# Hoja de modificaciones 4

Fecha modificación:	13/12/2023
Orden de producción:	DG-16.594-IK
Plazo de entrega:	
Cliente:	PRIMA LNG
Contacto:	Nenad
Teléfono:	
Comercial:	Jordi Segura

Project/Serial	DG-16594-IK	Date	16/04/2021
Drawn	DIMA	Checked	ADP
Scale	CRIOGENIC TANKS MODEL DCH-250-060-11	PRIMA LNG INDUSTRIAL TANK ( ITALY )

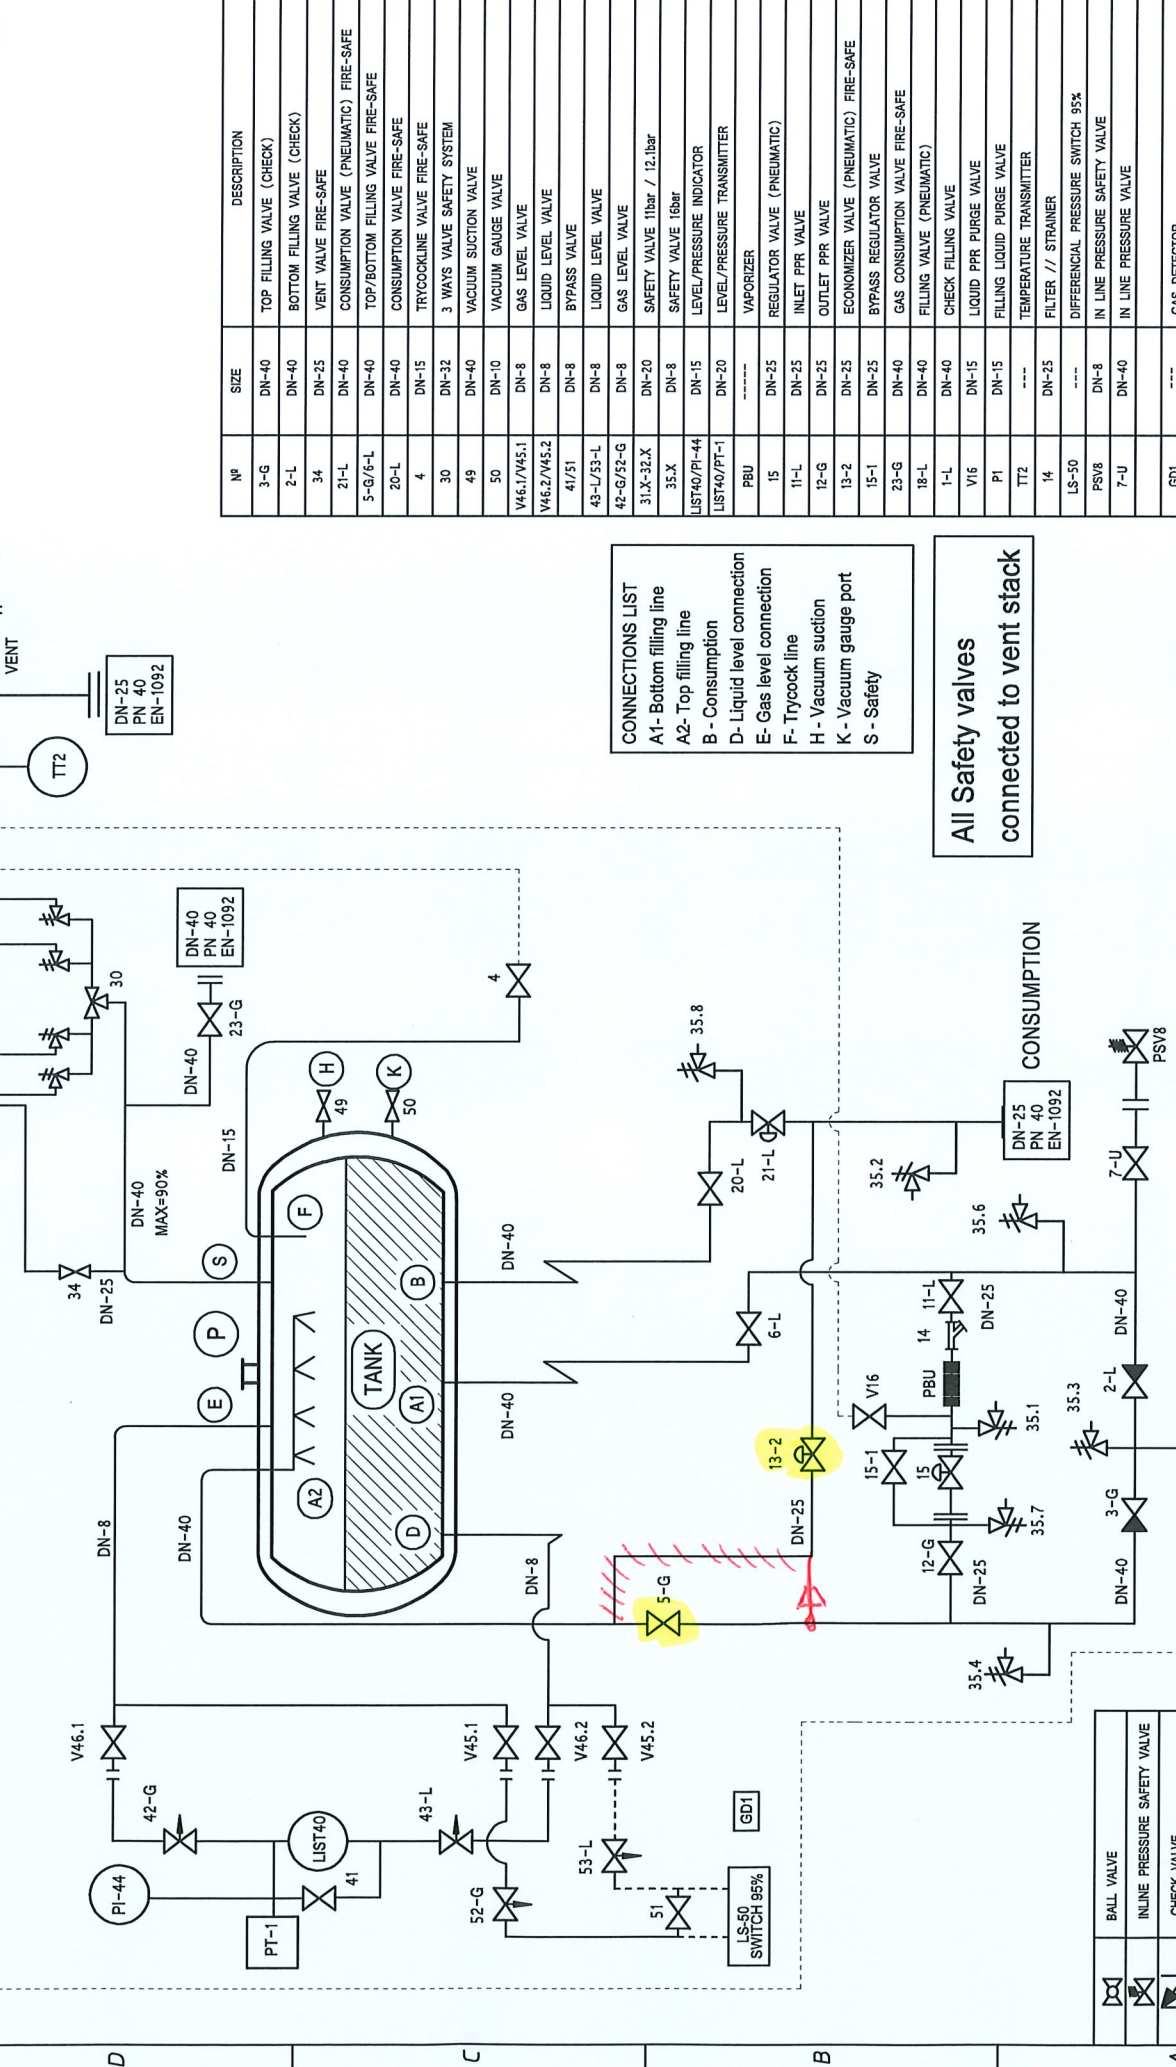
Ud.	Denominación	Precio unitario	Importe PVP
	Cambio conexión después válvula DN-25		890 €
		<b>Total</b>	<b>890 €</b>

Pneumatic valves 5-G and E-L has been changed to manual valves.
